SEWAGE DISPOSAL SYSTEM

HOWARD COUNTY HEALTH DEPARTMENT
BUREAU OF ENVIRONMENTAL HEALTH
461-9933

SUBDIVISION Highland Meadows LOT 8 ROAD 13325 Long Leaf Road

PERCOLATION TESTING

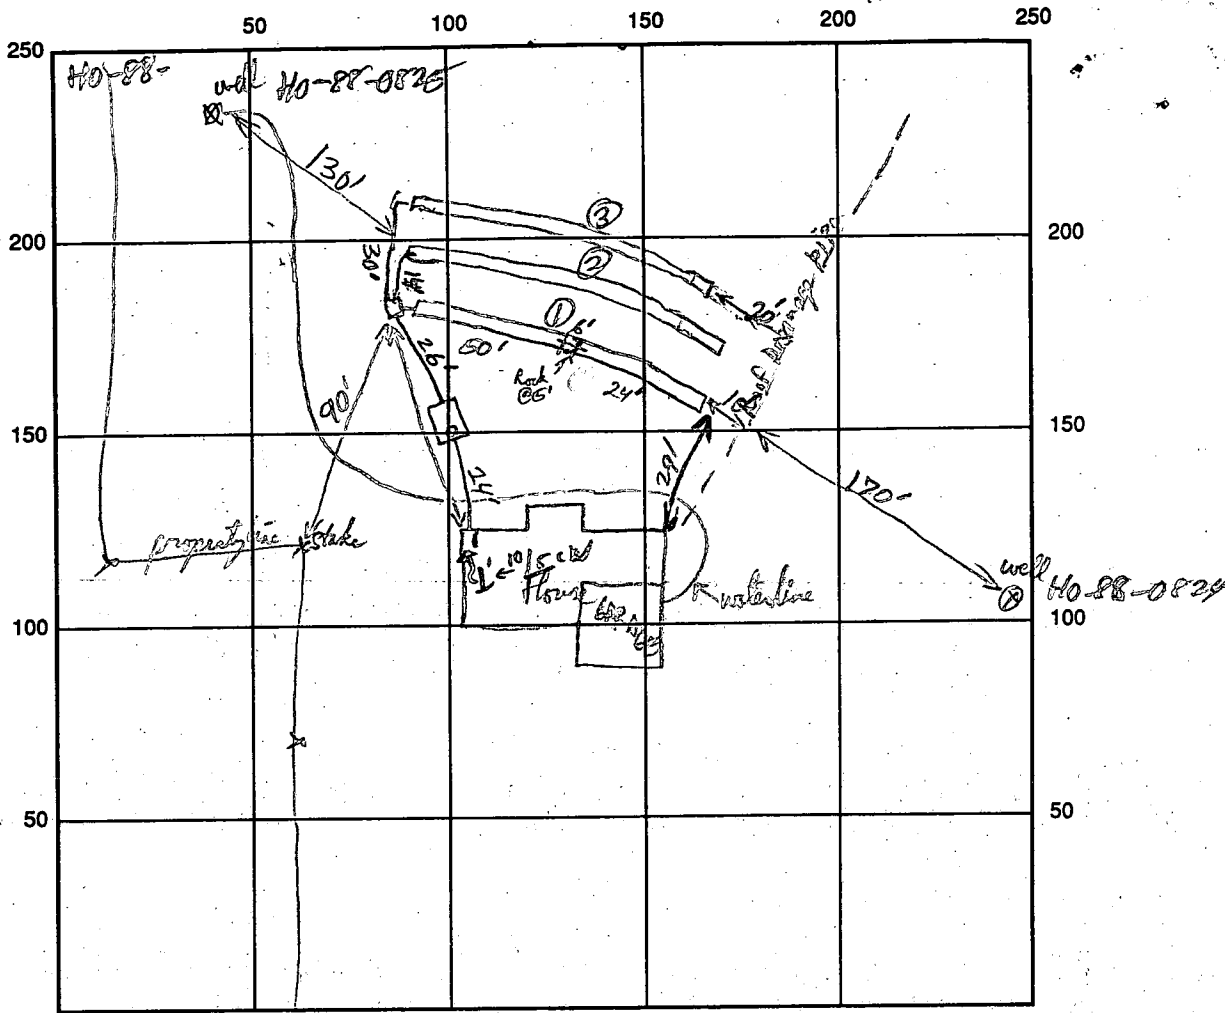
DISTRIBUTION BOX LEVEL OK (Baffle is in) Needs plug

REMARKS: 3 Trenches were laid to soil cover a 10' long rock outcrop in bottom of Trenches 1 and 2.
Checked with old pipe - rest of Trenches OK to Gravel Fill. Ref 80-2-92
A.M. 10/5/92 as per above; + material on site for final - final C. Bed

SOIL PROFILE

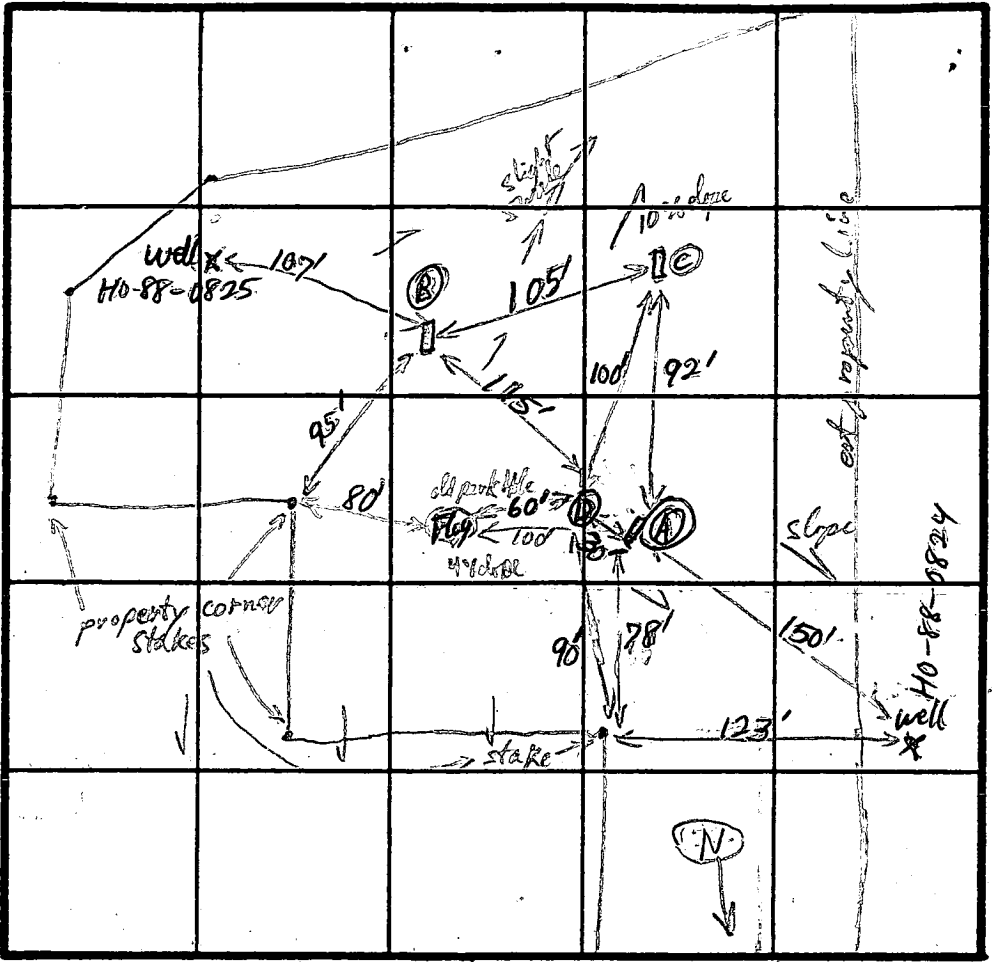
SUGGEST ROTATE SEPTIC AREA,
TEST HOLE LOCATIONS TO MORE
ACCURATELY REFLECT CONTOURS,
AND TO MAINTAIN LESS THAN 2/3/92 CWILL
DIRECT LINE OF FLOW TO NEIGHBORS WELLS.

REASONS FOR REJECTION OR HOLDING Re configure, away from Rocky Test Hole A + 2 wells. 2/14/92

Too Rocky to use and location is up hill of existing well (Maintain 25ft separation from Septic Area)

REMARKS Stay 25 ft From Rocky Test hole A - Reconfigure Area

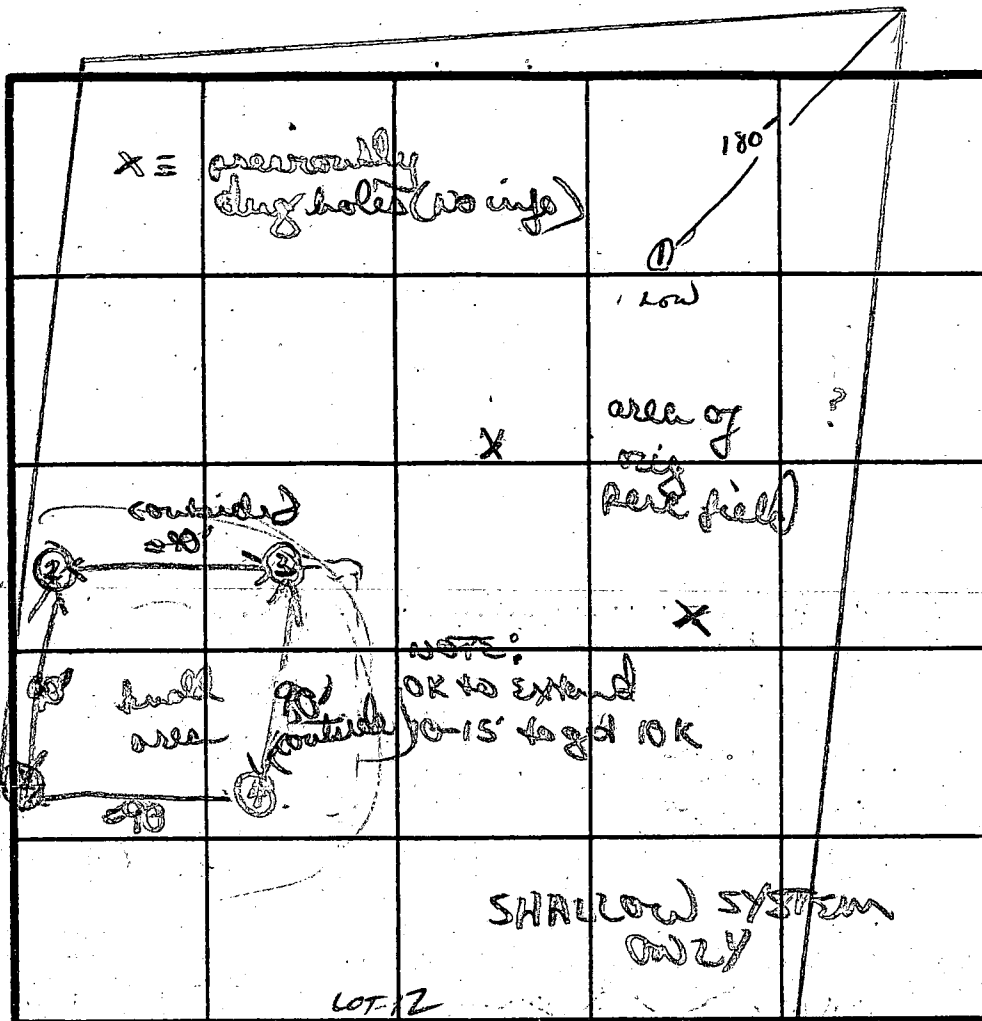
REASONS FOR REJECTION OR HOLDING 1659-88 Hold For wet season testing & REDESIGN. S. Abol

2/15/88 Prelim plot should show proper perc field. Possible House/well site missing

REMARKS: pers. field adjusted to highest part of property. Well sets need to go on lot 13. lot line adjustment needed for house/well area
